Access Compliance Report

Public Rights-of-Way

Intersection ID: 28846	Main Street: BRENELY_CT	Cross Street: FAIRCHASE_AV	Location: NE
ADA ID: 792B19C0801A	Ramp Type: PerpDiag	Initial Pass/Fail: Fail	Overall Compliance: No
		Severity Score: 10

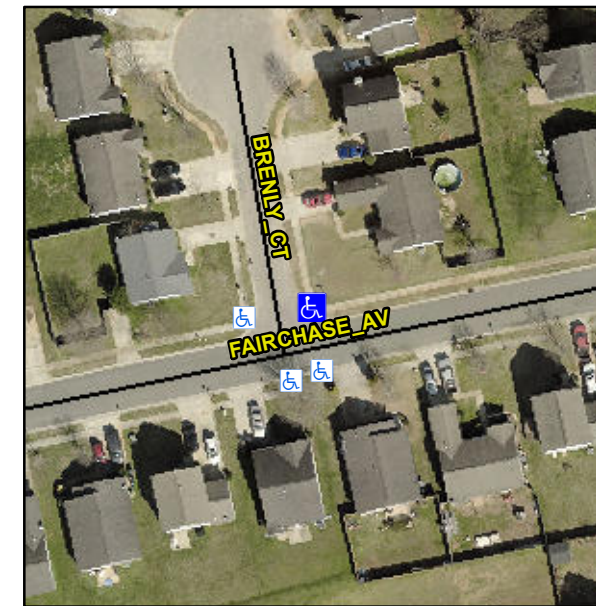
Not Found, R304.5.1, R304.5.3

Compliance	Description	Data	Compliance	Description	Data
N/A	Ramp Length (in)	92.0	Yes	Ramp Slope (%)	5.1
No	Ramp Width (in)	46.0	No	Ramp XSlope (%)	4.1
N/A	Flare Type LT	N/A	N/A	Flare Type RT	N/A
N/A	Flare Slope LT (%)	N/A	N/A	Flare Slope RT (%)	N/A
N/A	Flare Traversable LT?	N/A	N/A	Flare Traversable RT?	N/A
N/A	Landing Length (in)	N/A	N/A	DWS Provided?	N/A
N/A	Landing Width (in)	N/A	N/A	DWS Contrast?	N/A
N/A	Landing Slope (%)	N/A	N/A	DWS Length (in)	N/A
N/A	Landing X Slope (%)	N/A	N/A	DWS Full Width?	N/A
N/A	Landing Curb? (Y/N)	N/A	N/A	DWS Offset (in)	N/A
N/A	Shared Landing?	N/A			
N/A	Gutter Ponding?	N/A	N/A	Gutter Slope (%)	N/A
N/A	Gutter Lip Ht (in)	N/A	N/A	Gutter X Slope (%)	N/A
N/A	Painted X Walk1?	No	N/A	Painted X Walk2?	No
	X Walk 1 Direction	To W		X Walk 2 Direction	To S
N/A	X Walk 1 Width (in)	N/A	N/A	X Walk 2 Width (in)	N/A
	X Walk 1 Slope (%)	1.1		X Walk 2 Slope (%)	5.4
	X Walk 1 X Slope (%)	3.5		X Walk 2 X Slope (%)	0.0

Remove & Replace Curb Ramp With Two New Directional Ramps or Equivalent.
